Date: [10/16/09]

PCN No.: [120]

PRODUCT CHANGE NOTIFICATION, XPort 04

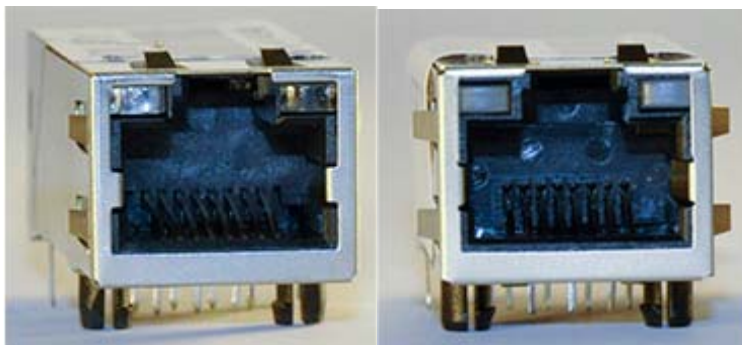
1. The number of spacers at the base of the XPort 04 were increased from 1 to 3 to add more placement stability. The height of the spacers remain the same.

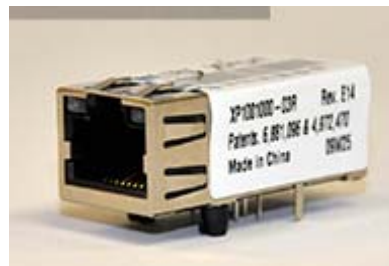
2. The XPort 03 has a solder ball visible on the back of the metal cover while the XPort 04 does not have this solder ball. The XPort 03 does not have tooling marks at the bottom of the unit while the XPort 04 does.
3. The XPort 03 has LEDs at the front while the XPort 04 uses light pipes. The wipers in the XPort 03 touch the top of the combs. The XPort 04 has wider combs which will show a small gap at the front of the comb.
